Office Action Summary	Application No. 10/561,927	Applicant(s) OHTA ET AL.	
	Examiner PHUTTHIWAT WONGWIAN	Art Unit 3741

DETAILED ACTION

FIG. 2

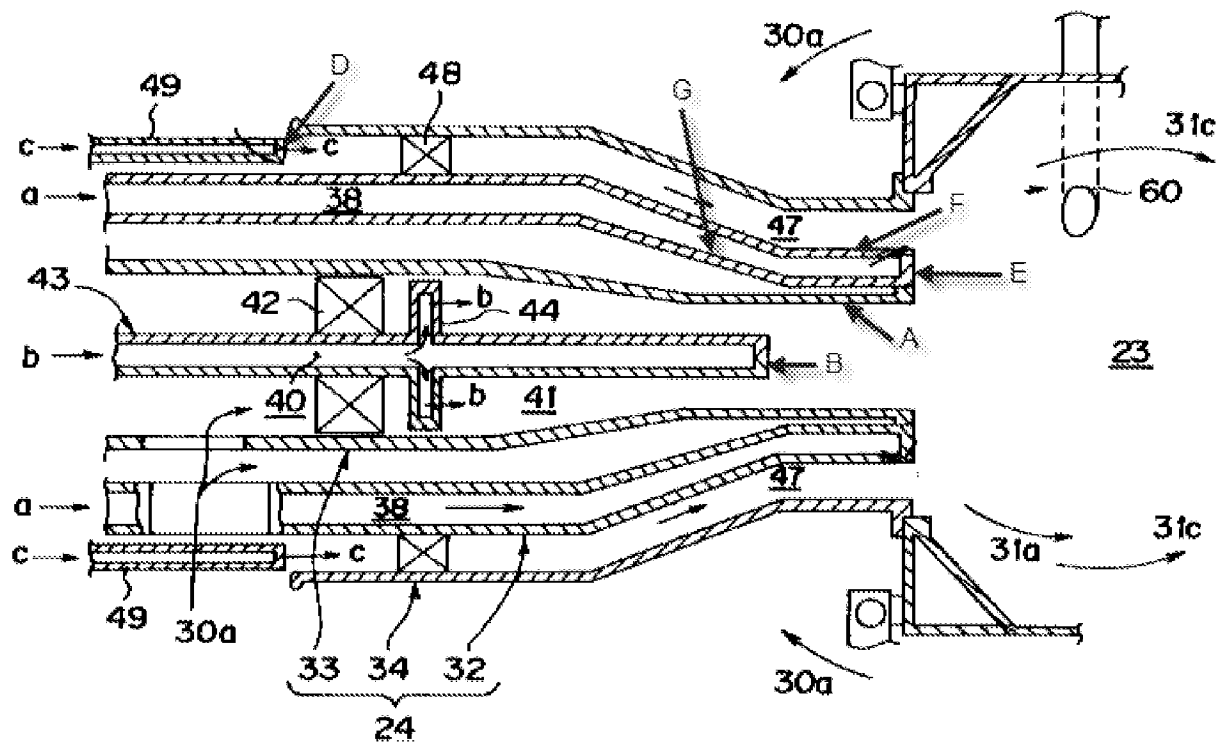
16. Claims 16 and 17 are rejected under 35 U.S.C. 102(b) as being anticipated by Iwai (US Patent No. 6,070,411).

17. As to claims 16 and 17, Iwai discloses a combustor 20 (fig. 1) comprising: a pilot nozzle 43 (fig. 2) being provided in a center portion (fig. 1) of a combustor main body 22 (fig. 1); a plurality of main nozzles 49 (fig. 2) being provided in a surrounding area of the pilot nozzle at regular intervals; a pilot cone A (fig. 2 above, when the angle is 0 degree) covering a downstream-side tip portion B (fig. 2 above) where a fuel b (fig. 2) of the pilot

nozzle flows; and main burners 47 (fig. 2) covering downstream-side tip portions D (fig. 2 above) of the main nozzles 49 (fig. 2); and wherein, the pilot cone comprises: a tapered portion A (fig. 2 above) of inner circumference of the cone A (fig. 2 above, when the angle is 0 degree) being formed in a tapered shape so as to stretch out in a radial pattern toward a downstream side; and a collar portion E (fig. 2 above) which is provided to an external periphery of a downstream-side tip E (fig. 2 above) of the tapered portion of inner circumference of a cone and serves as [intended use] a surface being approximately vertical to axial direction of the said pilot nozzle; and wherein, an angle (any angle, inherent) in axial direction to a line (any line) connecting an external periphery of a downstream-side tip of the pilot nozzle and an external periphery of downstream-side tips of the main burners is specified as " α ," an opening angle of the tapered portion of inner circumference of a cone " θ " is " $0 \leq \theta \leq 2\alpha$." (when the angle is 0 degree) wherein, an outer circumference F (fig. 2 above) of the tapered portion of inner circumference of a cone is provided with a cylinder (fig. 1-2) being shaped so as to be along an outer wall G (fig. 2 above) of the tapered portion A (fig. 2 above) of inner circumference of the cone and the collar portion.
